**LEGAL ADVERTISEMENT
HISTORIC PRESERVATION BOARD
CITY OF PORTLAND
Public comments are taken at all meetings.**

HISTORIC PRESERVATION BOARD AGENDA

**WORKSHOP
113 WINTER STREET**

RE: July 15, 2015 Preliminary review – rooftop dormer addition

113 WINTER ST. #2
 PROPOSED SOUTH ELEVATION
 3/8" = 1'0"

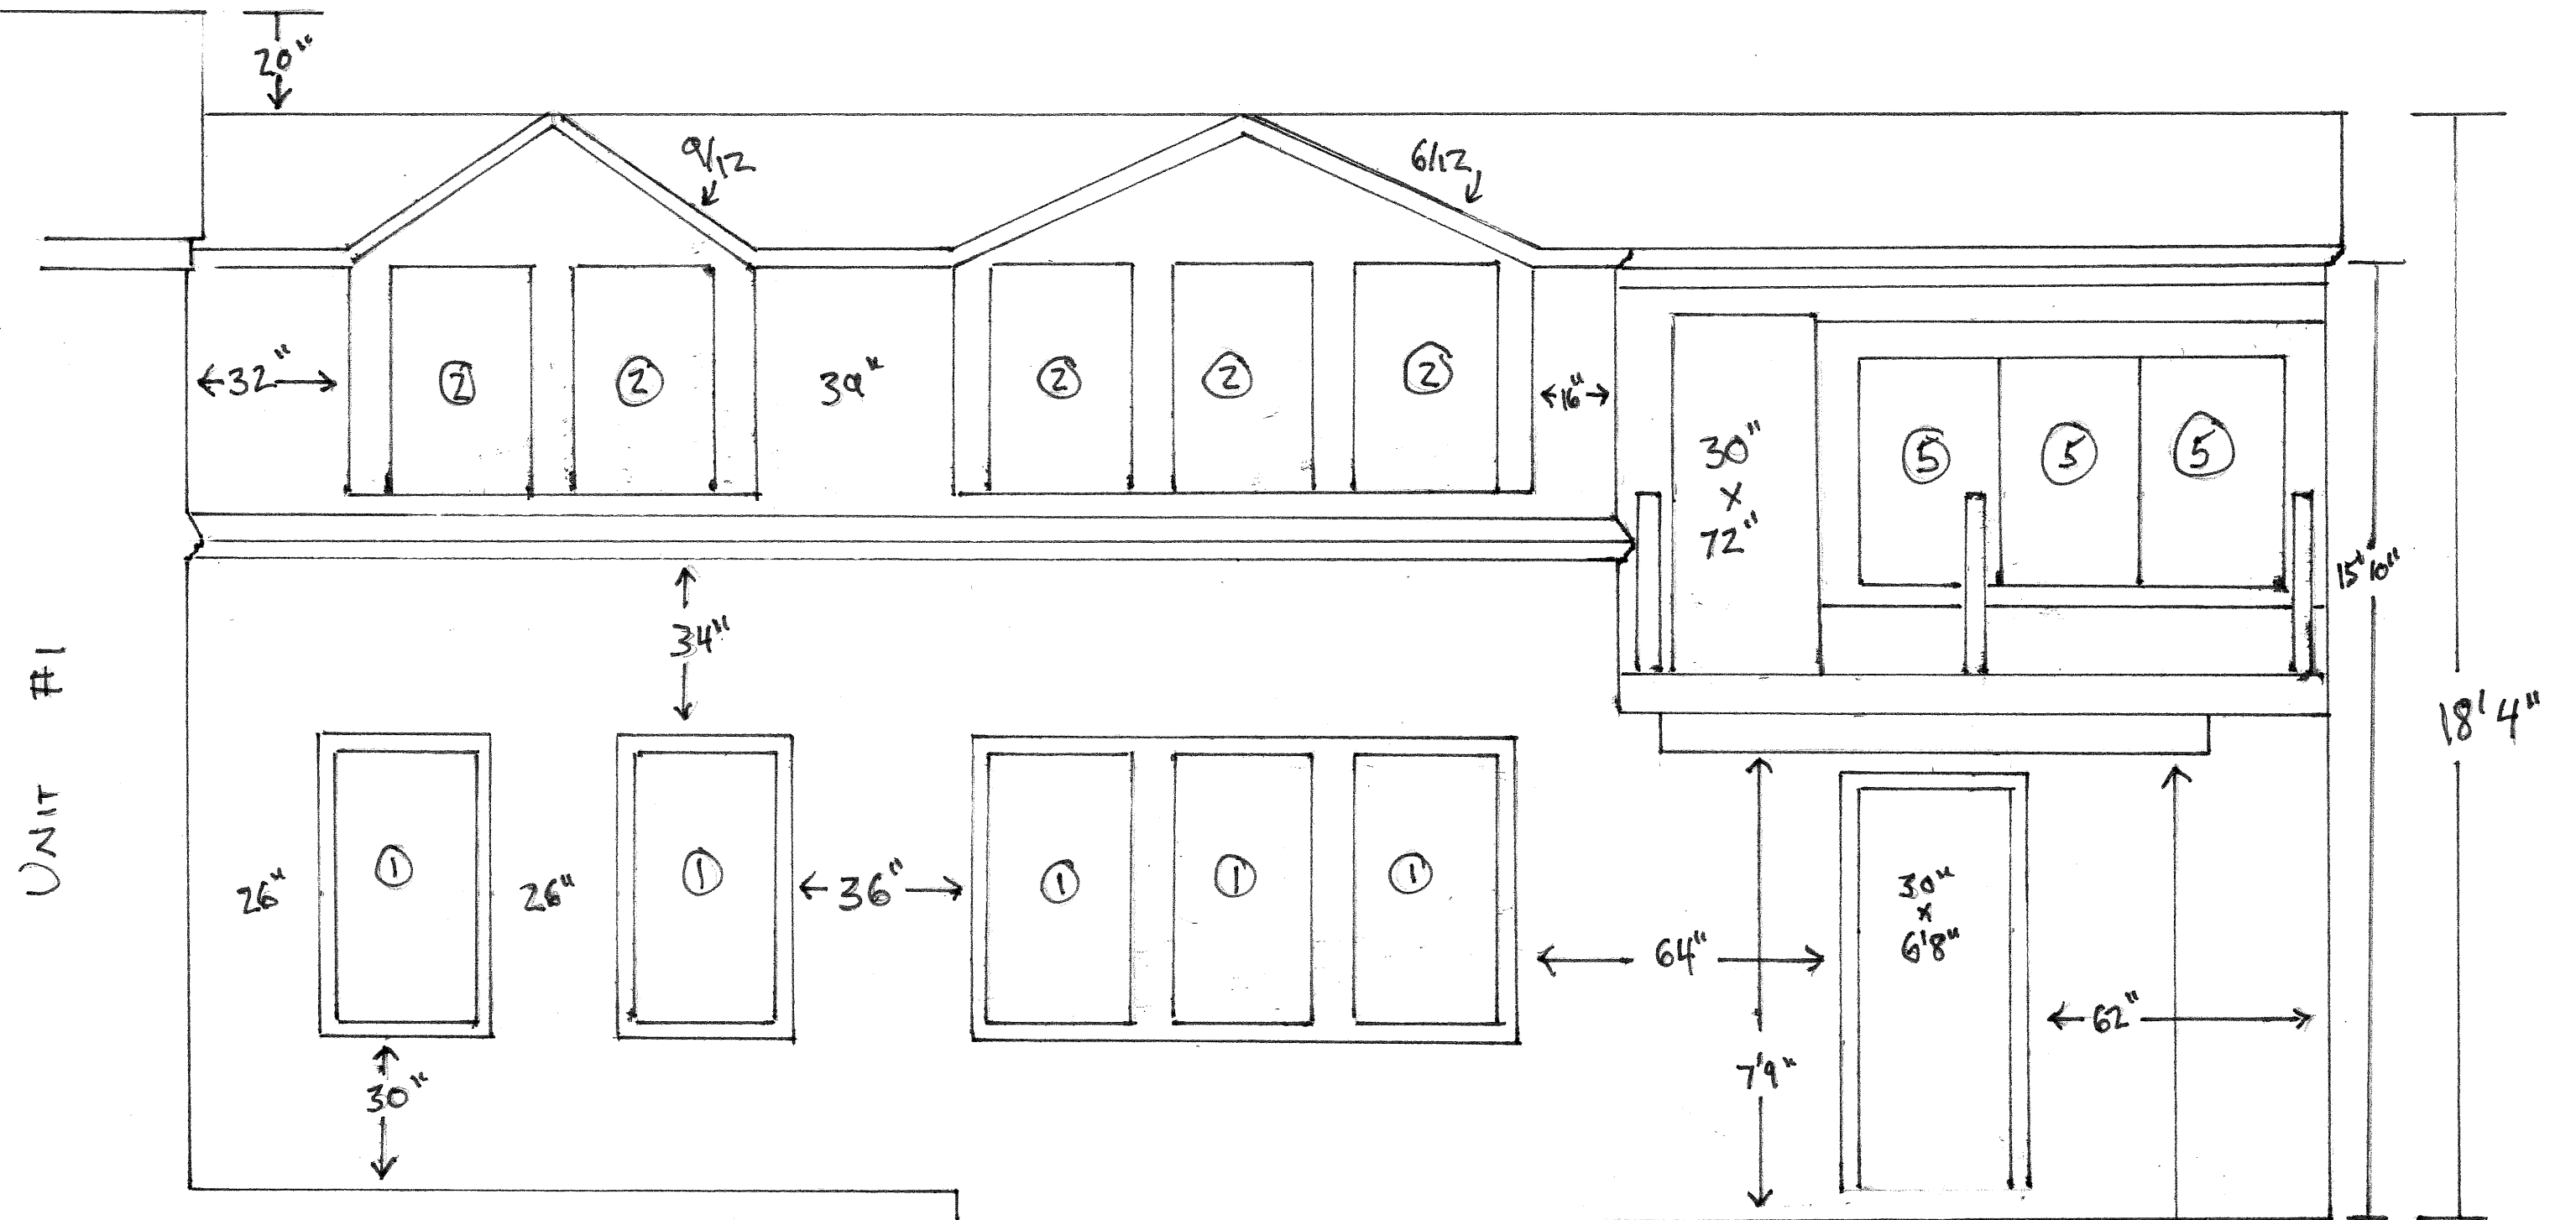
EXTEND RAFTERS UNDER
 DECK FOR 2' COVERED
 ENTRY SHED ROOF
